| IN no.: 145 rev 1.0 | Date: 2020-03-19 |
| Device affected: nRF9160-SIAA nRF9160-SIBA nRF9160-SICA | Device version / Build Code: B1A |

Description of change:
Marking to add country-specific certification numbers

Fig 1: Sample current marking for SICA variant Fig 2: Sample new marking for SICA variant

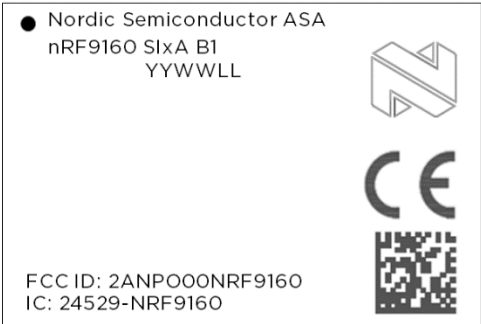
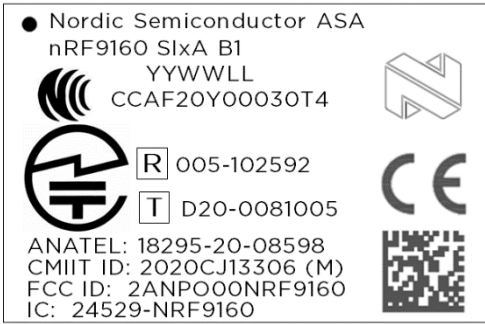
| FROM | TO |
|---|--|
|  <p>● Nordic Semiconductor ASA nRF9160 S1xA B1 YYWWLL</p> <p>FCC ID: 2ANPO00NRF9160 IC: 24529-NRF9160</p> |  <p>● Nordic Semiconductor ASA nRF9160 S1xA B1 YYWWLL CCAF20Y00030T4</p> <p>ANATEL: 18295-20-08598 CMIIT ID: 2020CJ13306 (M) FCC ID: 2ANPO00NRF9160 IC: 24529-NRF9160</p> |

Reason for change:
To comply with regulatory requirement of target market areas – China, Taiwan, Japan, and Brazil. Specific Certification ID numbers added to enable use of the nRF9160 in these countries.

Fig 3: Identification of affected devices on labels and top side marking

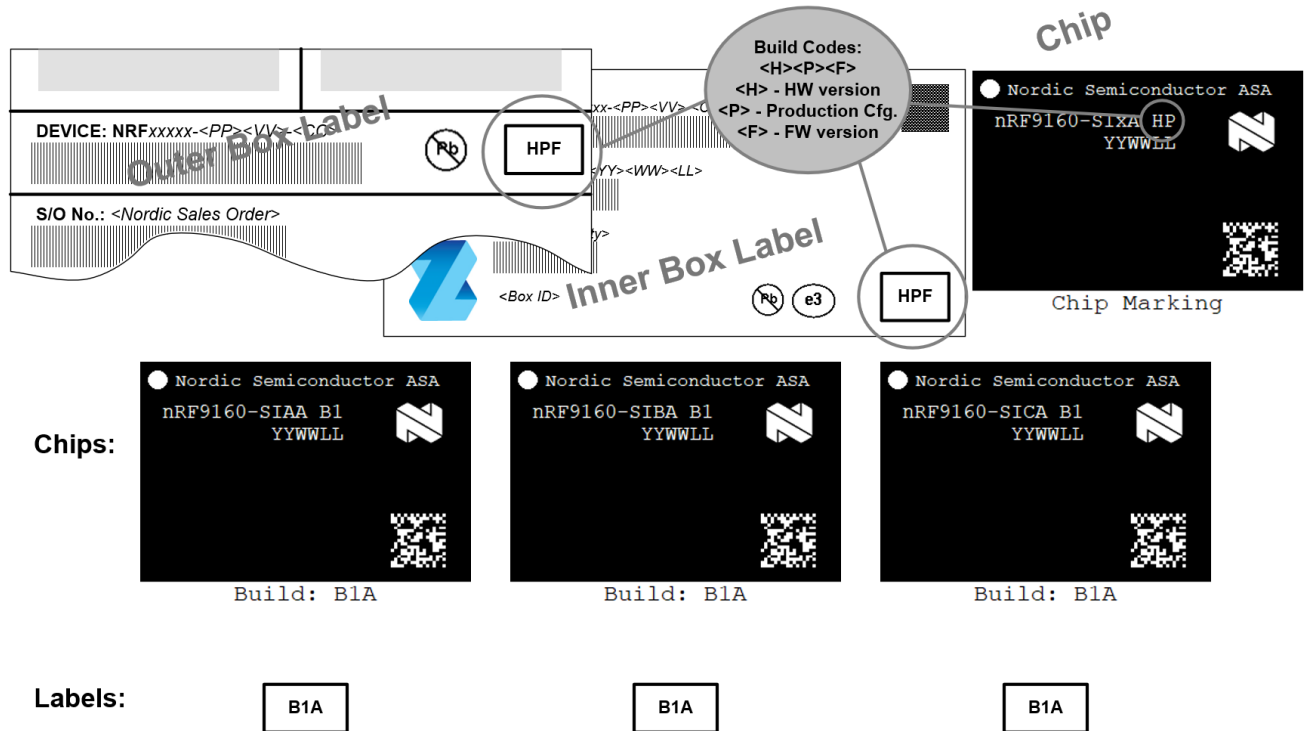
Marking/Shipping labels:
